**IEEE P802.15  
Wireless Personal Area Networks**

Project	IEEE P802.15 Working Group for Wireless Personal Area Networks (WPANs)
Title	UWB Packet Format Configuration
Date Submitted	9 December 2024
Source	Billy Verso (Qorvo), <span style="float: right;">billy.verso at qorvo.com</span>
Re:	IEEE P802.15.4ab Comment Resolutions
Abstract	Comment Resolutions for selected comments on the LB207 / P802.15.4ab D01.
Purpose	This document provides text changes intended to be part of the final IEEE Std 802.15.4ab (amendment to IEEE Std 802.15.4), as part of resolving selected comments from the consolidated spreadsheet (doc 15-24-0371) that have been assigned to the author to resolve.
Notice	This document does not represent the agreed views of the IEEE 802.15 Working Group or IEEE 802.15.8 Task Group. It represents only the views of the participants listed in the "Source(s)" field above. It is offered as a basis for discussion and is not binding on the contributing individual(s) or organization(s). The material in this document is subject to change in form and content after further study. The contributor(s) reserve(s) the right to add, amend or withdraw material contained herein.

Figure 198—HRP-ARDEV MMS packet formats

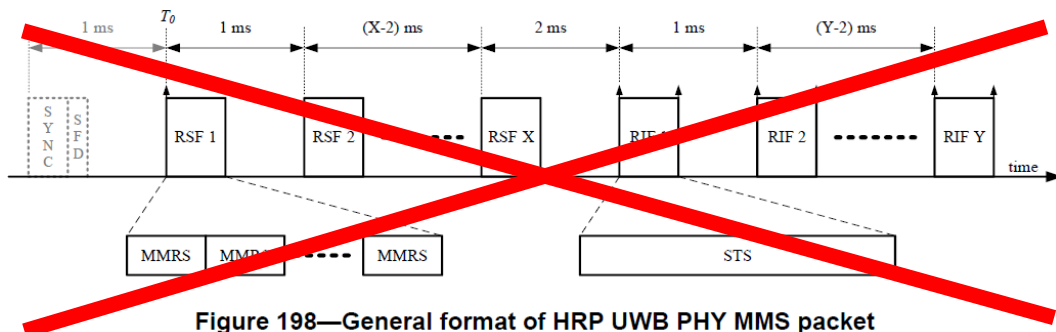
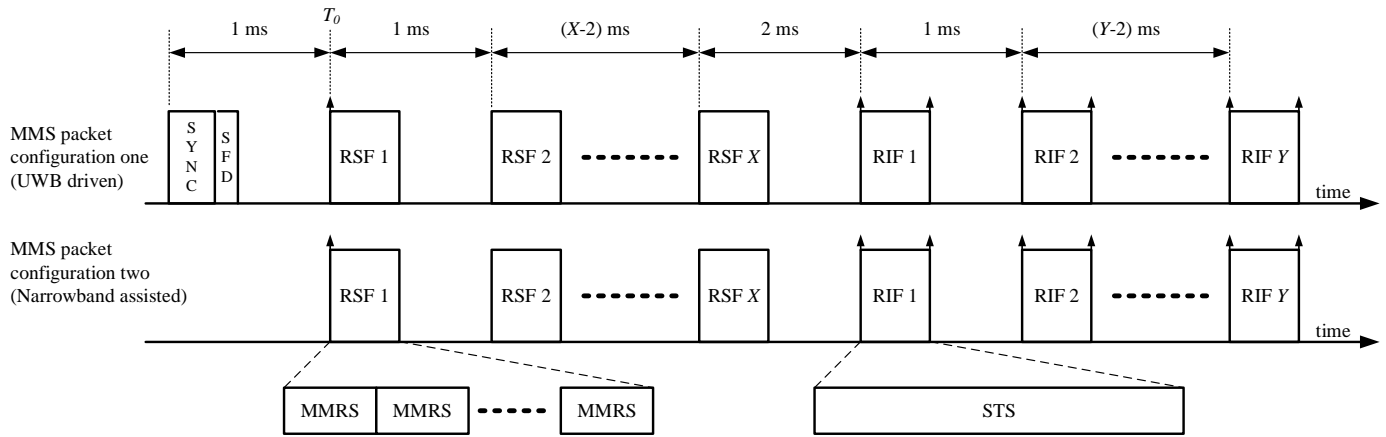
Now Figure 198 referenced in the Table X above needs update to show the two MMS packet formats separately. (This was also in 0552r1)

Figure 10-206—Message sequence chart for SS-TWR using SP3 packets

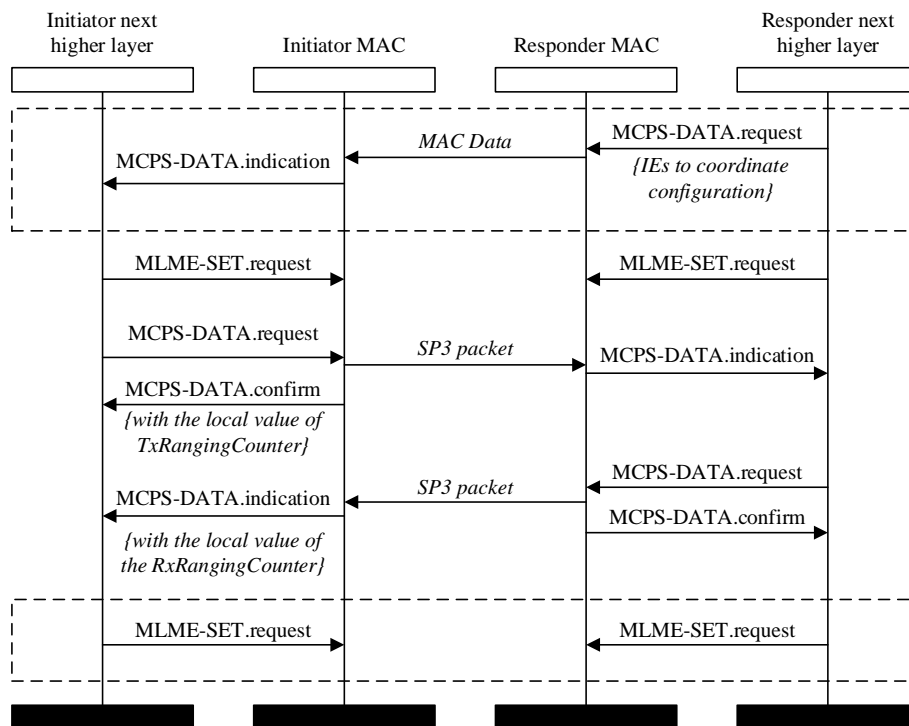
The next place where the MLME-STS primitive is used is in the base standard clause 10.29.6.5 and the changes necessary to capture (in 4ab) its replacement by MLME-SET are as follows:

Replace Figure 10-206 with the following:

The next higher layer is responsible for properly configuring the operation at each end using the ~~MLME-STS.request~~ MLME-SET.request primitive to configure the SP3 packet format at both ends, and for setting the PIB attributes *phyHrpUwbStsSeed*, *phyHrpUwbStsVCounter*, and *phyHrpUwbStsVUpper96* to the correct values. Once the higher layer has selected the SP3 packet configuration, subsequent MCPS-DATA primitives relate to SP3 packets, until the higher layer uses the ~~MLME-STS.request~~ MLME-SET.request primitive to change the packet configuration.

The ranging exchanges are repeated as many times as the higher layers have mutually agreed. To resume PHY and MAC data interactions, the next higher layer uses the ~~MLME-STS.request~~ MLME-SET.request primitive to restore the ~~STS~~ packet configuration to a value that allows such data interactions. This is shown in the final dashed box in Figure 10-206.
